Well Name: FEDERAL 12	Well Location: T22S / R31E / SEC 12 / SWSW / 32.40573 / -103.737912	County or Parish/State: EDDY / NM
Well Number: 1	Type of Well: INJECTION - ENHANCED RECOVERY	Allottee or Tribe Name:
Lease Number: NMNM29233	Unit or CA Name:	Unit or CA Number:
US Well Number: 3001526742	Well Status: Water Disposal Well Shut In	Operator: OXY USA INCORPORATED

Notice of Intent

Type of Submission: Notice of Intent	Type of Action: Plug and Abandonment
Date Sundry Submitted: 10/25/2022	Time Sundry Submitted: 08:53
Date proposed operation will begin: 11/25/2022

Proposed Wellbore  
**Federal 12 - 001 SWD**  
30-015-26742-0000  
Eddy County NM

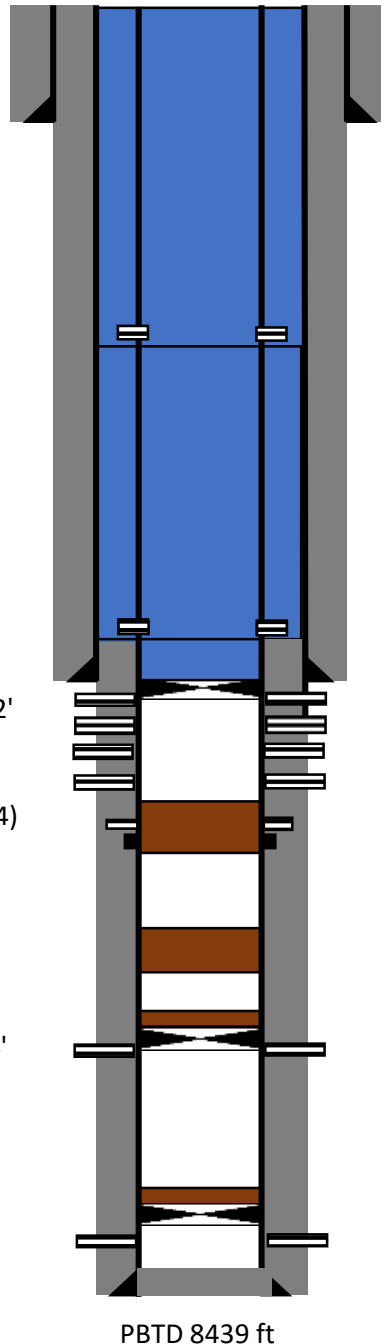
**BLM Note: Procedure OK as proposed**GEOLOGIC TOPS

Sundry ID		2699557				
Plug Type	Top	Bottom	Length	Tag	Sacks	Notes
Surface Plug	0.00	4450.00	4450.00	Verify circulated to surface	1160.00	R111P area. Perf and sqz from 4450 to 2200'(580sx) and 2200' to surface(580sx)
Shoe Plug	769.72	878.00	108.28	WOC and Tag	1160.00	R111P area. Perf and sqz from 4450 to 2200'(580sx) and 2200' to surface(580sx)
Top of Salt @ 1129	1067.71	1179.00	111.29	WOC and Tag	1160.00	R111P area. Perf and sqz from 4450 to 2200'(580sx) and 2200' to surface(580sx)
Base of Salt @ 4195	4103.05	4245.00	141.95	WOC and Tag	1160.00	R111P area. Perf and sqz from 4450 to 2200'(580sx) and 2200' to surface(580sx)
Shoe Plug	4231.75	4375.00	143.25		1160.00	R111P area. Perf and sqz from 4450 to 2200'(580sx) and 2200' to surface(580sx)
Delaware @ 4480	4385.20	4530.00	144.80		1160.00	R111P area. Perf and sqz from 4450 to 2200'(580sx) and 2200' to surface(580sx)
CIBP Plug	4587.00	4622.00	35.00	WOC and Tag	5.00	Dumb bail. Leak test 500psi, 30mins

**No more than 2000' is to be allowed between plugs in open hole, and no more than 3000' between plugs in cased hole.**

**R111P: Solid plug in all annuli - 50' from bottom of salt to surface.**
